# **REQUEST FOR PROPOSAL**

**No. 38514-01**

**Addendum No. 2**

## **ITEM 1: Buffalo Color and Riverbend Habitat Site Photos**

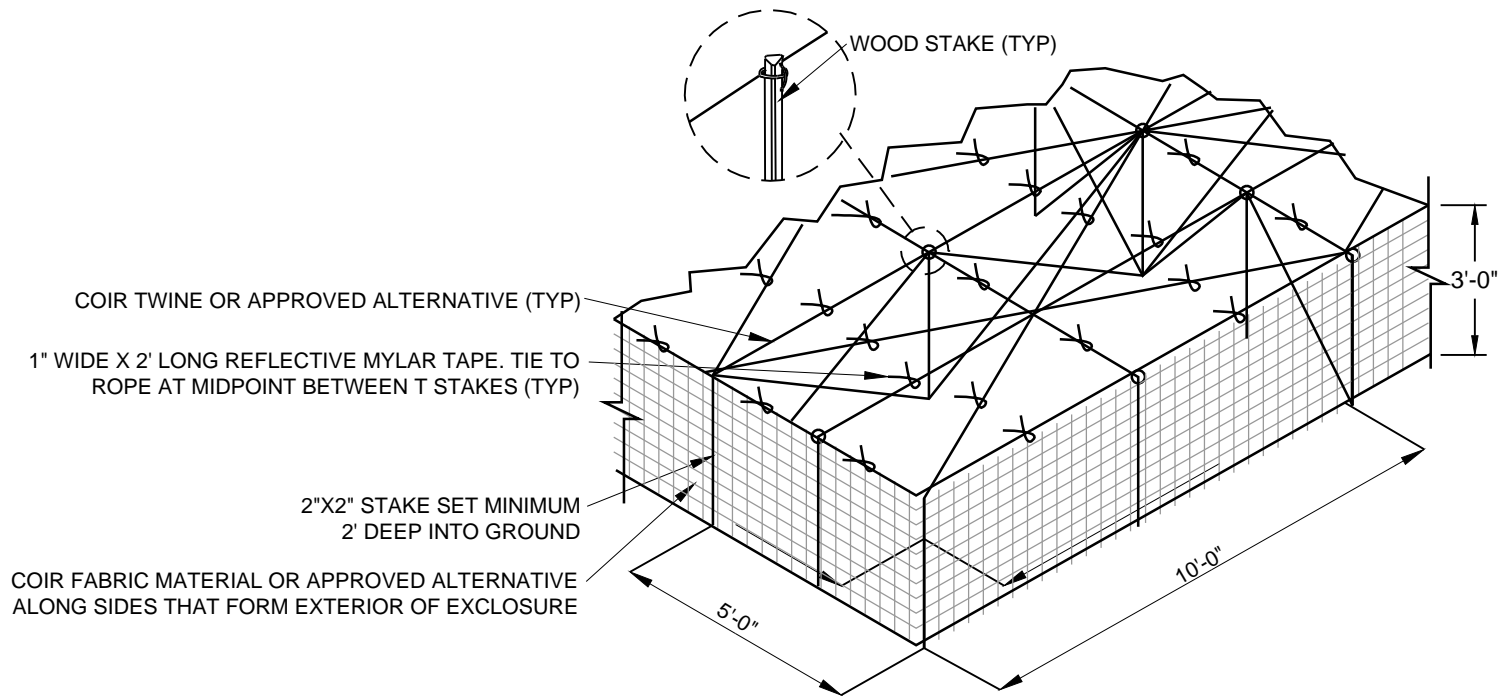
Question #6: Can you please provide a specification and a diagram of a typical herbivory protection.

Response: The Bidder is directed to technical specification Planting Preparation Section 32 91 00 1.04(A)(1) which outlines the requirements of the Planting Plan. The Bidder shall include description of herbivory protection in their Planting Plan as part of the submittal process, as well as a description in the proposal work plan. A conceptual detail of an acceptable protection system is included as Figure 1 to this Addendum and should be considered for information purposes only.

**NOTE:** Detail is provided for conceptual purposes only. Herbivory Protection detail to be provided by the selected contractor per Project Technical Specifications.
